CONSTRUCTION PLAN
APPROVED
FOR CONSTRUCTION BY THE
WESTERN VIRGINIA WATER
AUTHORITY

REVISION	STATE	ROUTE	PROJECT	SHEET NO.
	VA.		0581-128-109, PE-101 RW-201, C-501, B-627	18(7)

FINAL PLANS

PROJECT	SHEET NO.
0581-128-109	18(7)

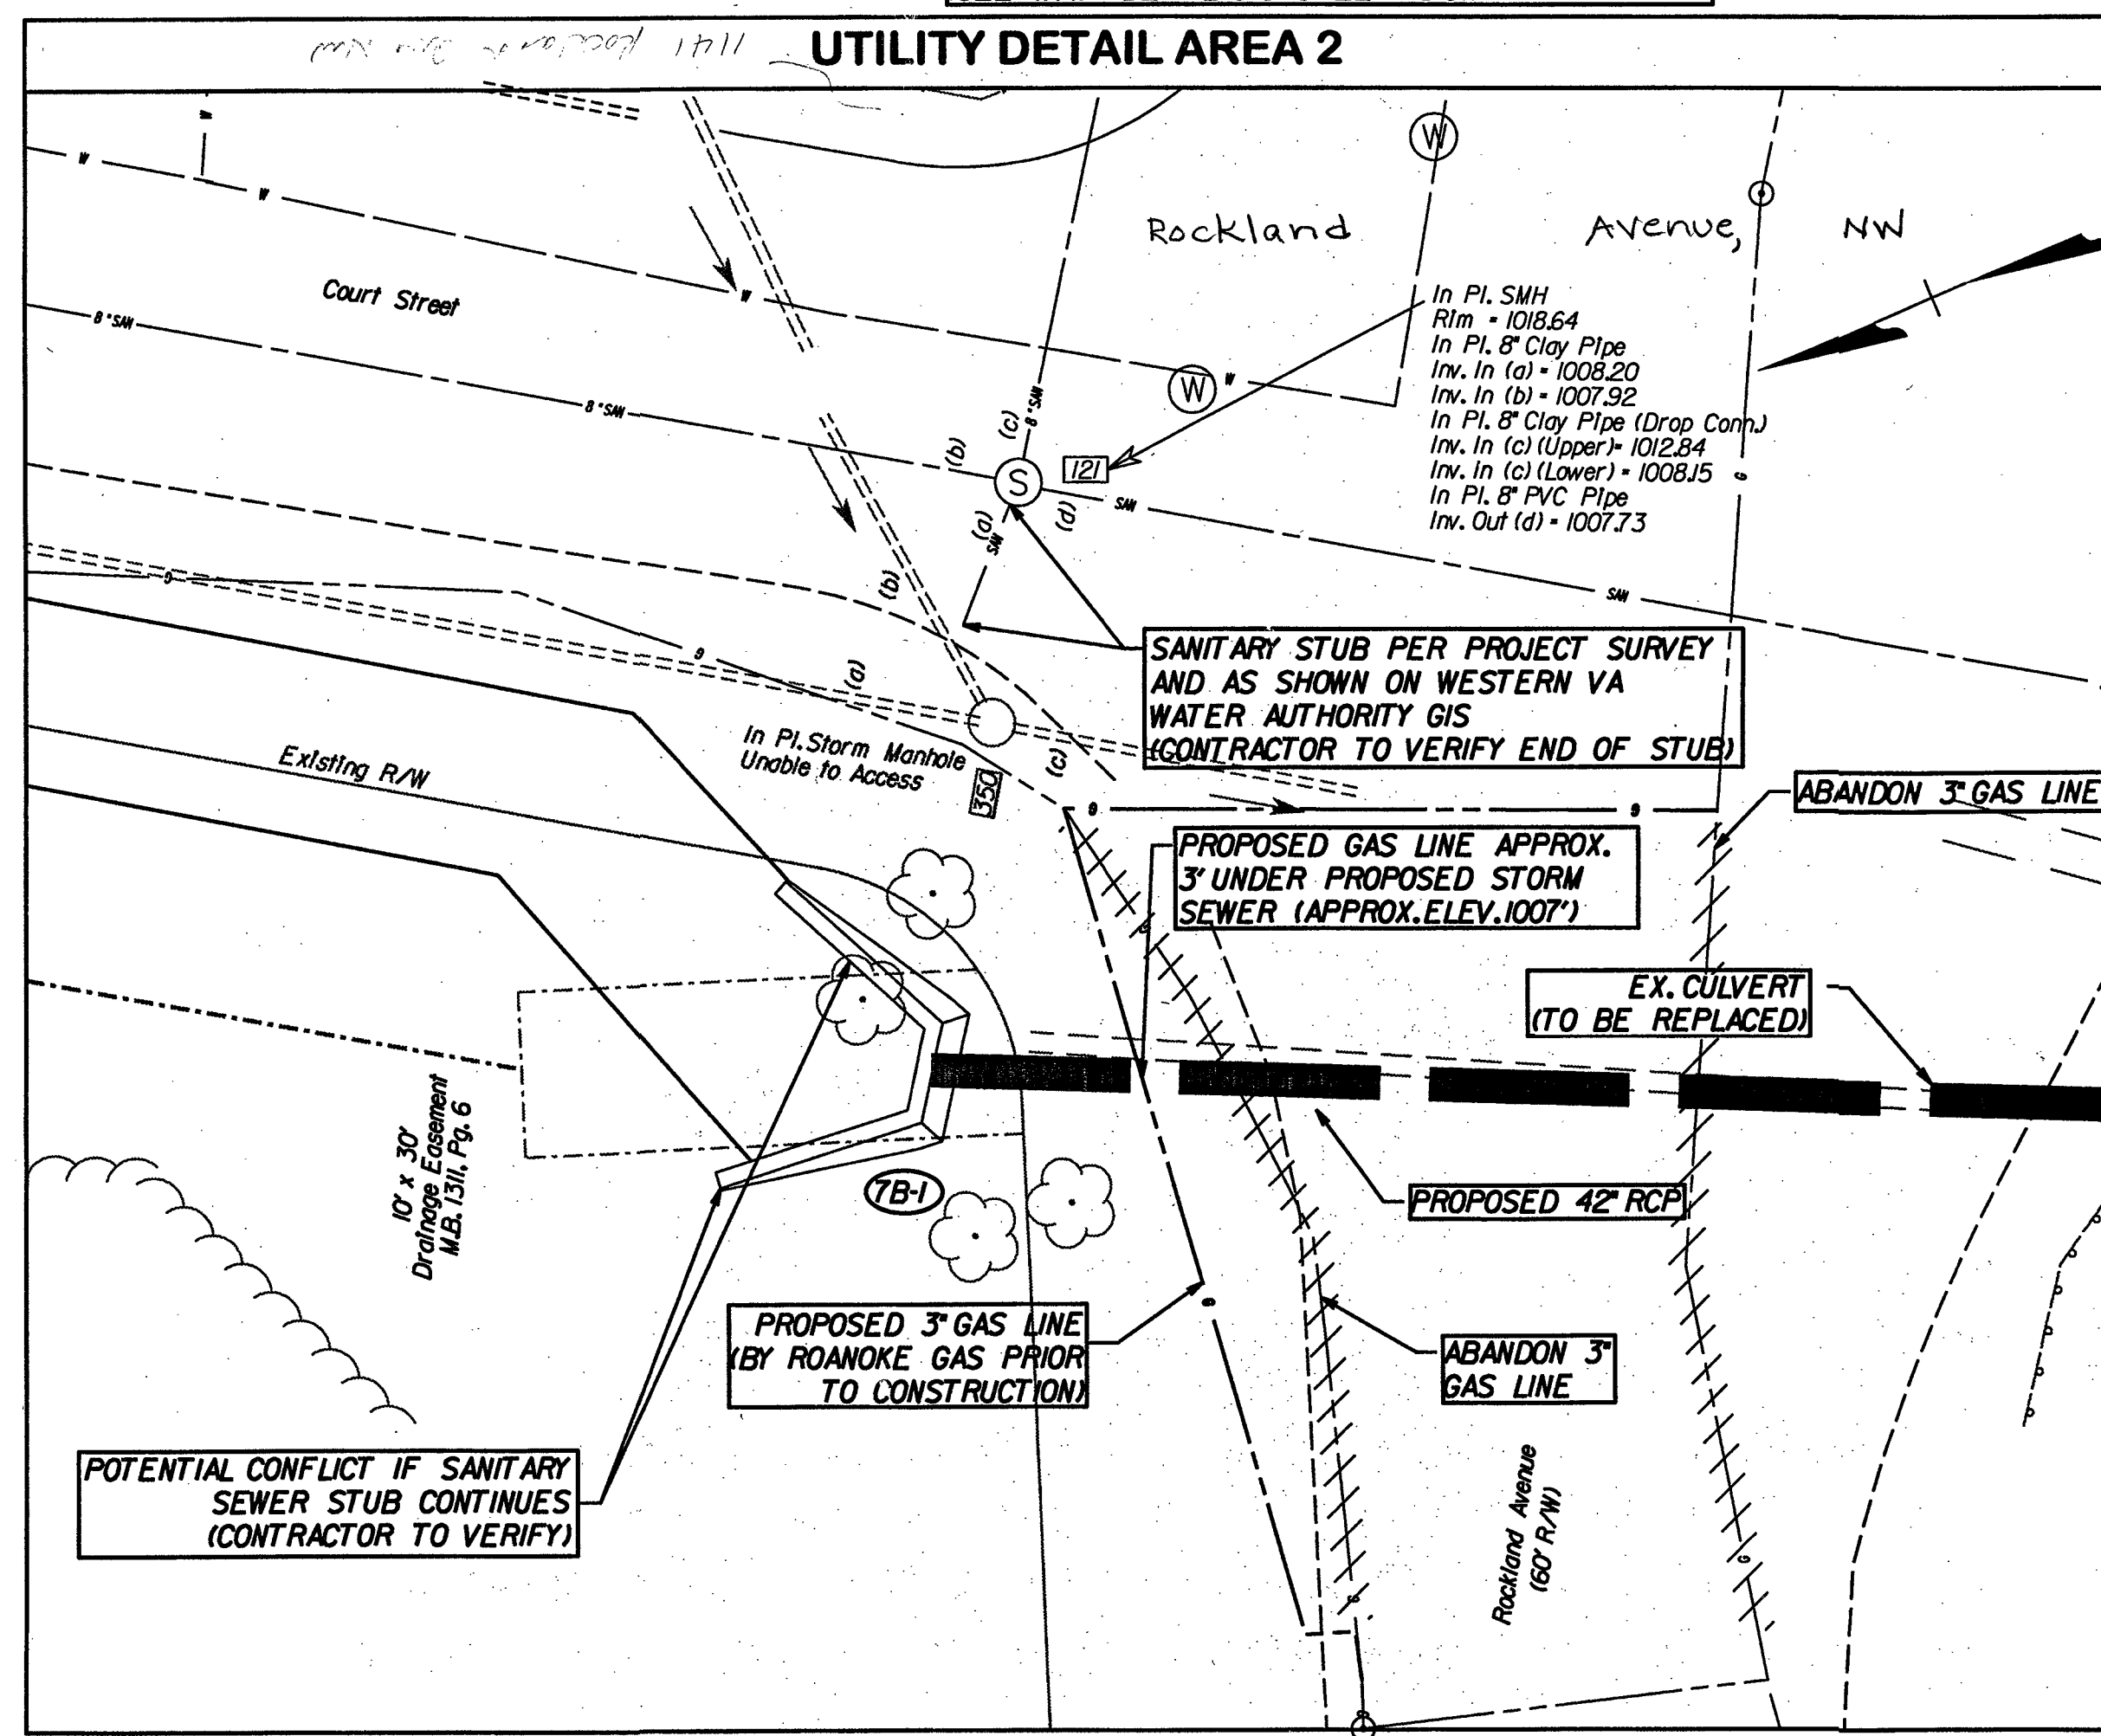
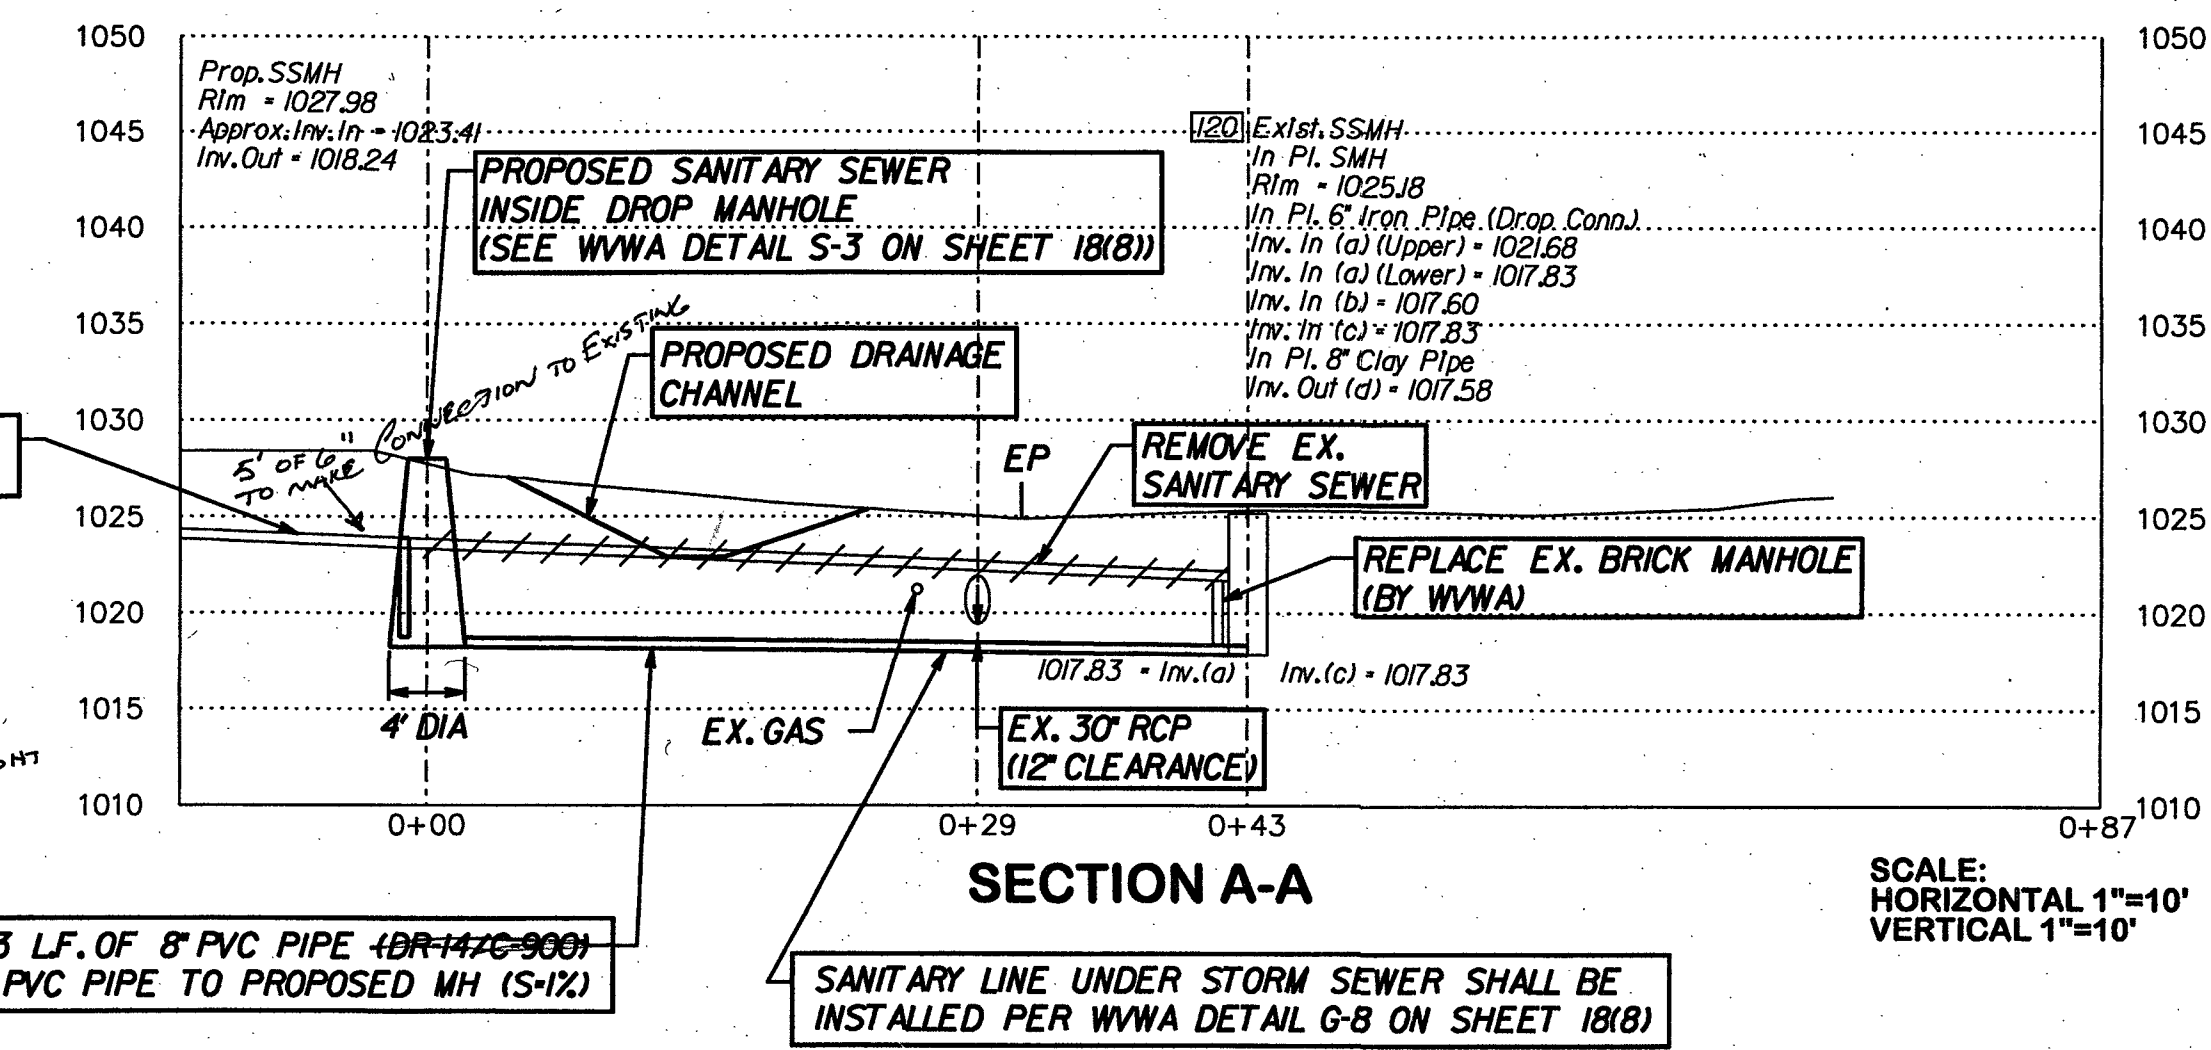
06-22-15
COMPLETED WATER SERVICE INSTALLATION.
2" ENDOT HDPE DR9 PE4710 PIPE

06-29-15
COMPLETED SANITARY SEWER INSTALLATION
8" NATIONAL SDR 35 PVC
6" NATIONAL SDR 26 PVC
CP & P SSMH 5' DIAMETER PRE-CAST CONCRETE
EAST JORDAN IRON WORKS FRAME & COVER. WATER TIGHT
07-17-15: PRESSURE TESTED NEW 8" LINE 3 PASSED
VACUUM TESTED NEW SSMH 3 PASSED
07-01-15 CHECKED WITH POLE CAMERA.
(KEVIN BRYANT.)
